CERTIFICATE OF THE SECRETARY OF ENERGY AND ENVIRONMENTAL AFFAIRS
ON THE
ENVIRONMENTAL NOTIFICATION FORM

PROJECT NAME : Dorchester Bay City
PROJECT MUNICIPALITY : Boston
PROJECT WATERSHED : Boston Harbor
EEA NUMBER : 16277
PROJECT PROPONENT : Bayside Property Owner, LLC and Morrissey Property Owner, LLC
DATE NOTICED IN MONITOR : October 7, 2020

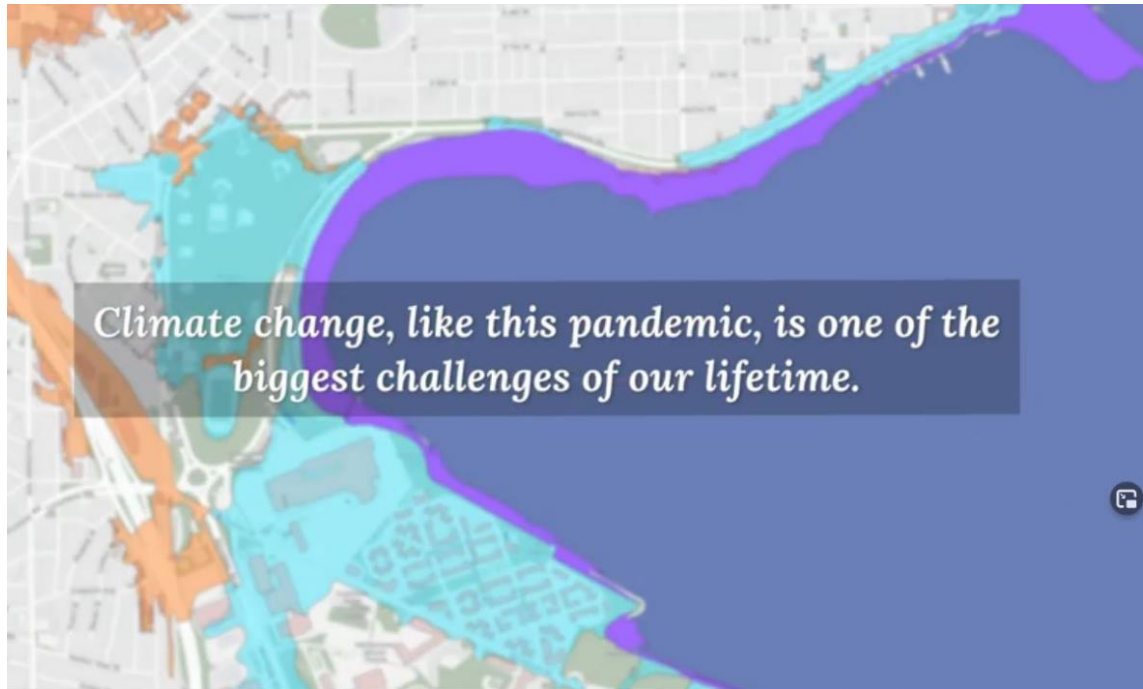
Excessive and too close to public beach and protected Dorchester Shores Reservation waterfront. **It does not fit!**

Please request to remove/scale down buildings A, B and C that would impact public waterfront.
